USB Power Delivery ENGINEERING CHANGE NOTICE

Title: EPR_Source_capabilities to force sink to Exit EPR
Applied to: USB Power Delivery Specification Revision 3.2
Version 1.0

As per some discussion in Compliance working group, EPR_source_capabilities construction when source wants to force Sink to exit EPR mode is not clear enough. This ECN clarifies this use case

Figure 6-53 “Mapping SPR Capabilities to EPR Capabilities”

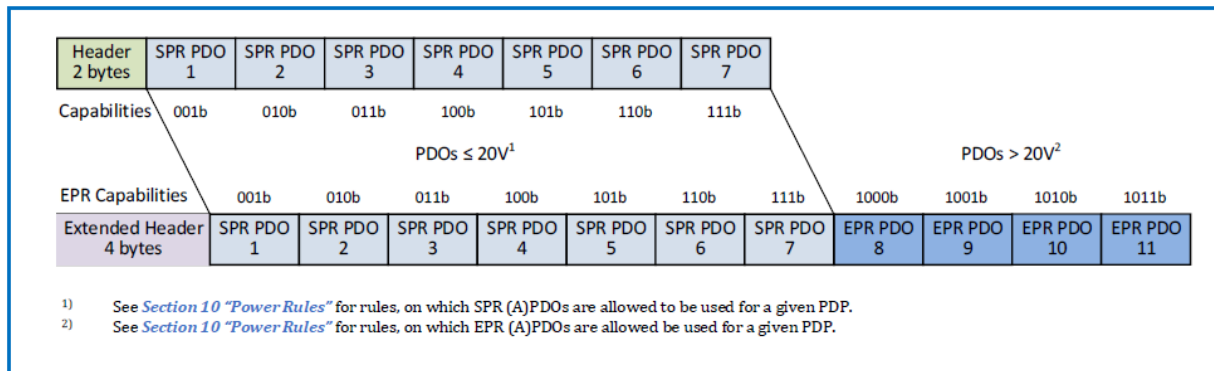
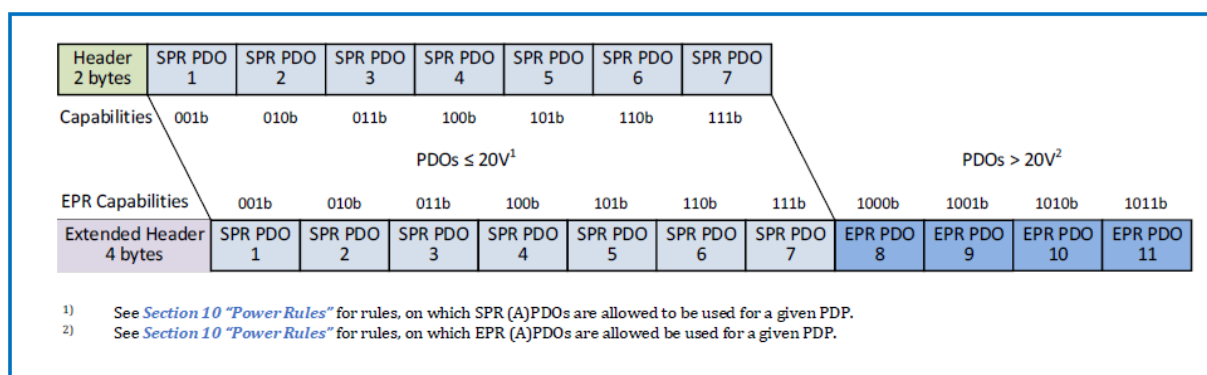
From Text:

To Text:

When Source wants to exit EPR mode, if not already in power contract with an SPR (A)PDO, it shall send an *EPR_Source_Capabilities* message with no EPR PDOs (i.e seven SPR PDOs including any zero padded ones). See Figure 6-x “*EPR_Source_Capabilities* message with no EPR PDOs”.
